**Flood Control Project Maintenance
Levee Inspections**

Maintenance Issue Types Only, Levee Inspection Report By Mile - Spring 2021

Reclamation District No. 0765 Glide

Waterway	Bank	Unit Miles	Inspection Start/End	Inspector
Unit No. 01 Sacramento River	Right	1.72	04/01/2021 04/01/2021	Saskia Donovan

Photo 1 of 1 : SP_2021_RD0765_211_1_20210308_00001.jpg

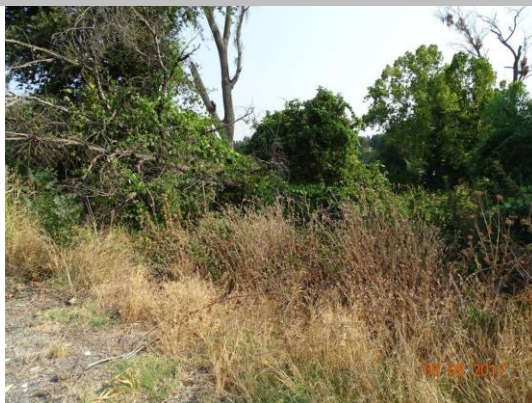
LM Start	1.58	Rating **	M	Issue No.	1
LM End	1.58	Issue Type +	Ma	Location *	WS
Category	Earthen Levee			GPS Latitude/Longitude	
				Start	End
Item	Encroachments			38.481959 °	38.481959 °
				-121.550527 °	-121.550527 °
DWR ID	DWR_RD0765_01_f_2017_1				
Comment Code					
TR : Tree or limb					
Inspector Comment					
Remove a fallen tree on the waterside slope.
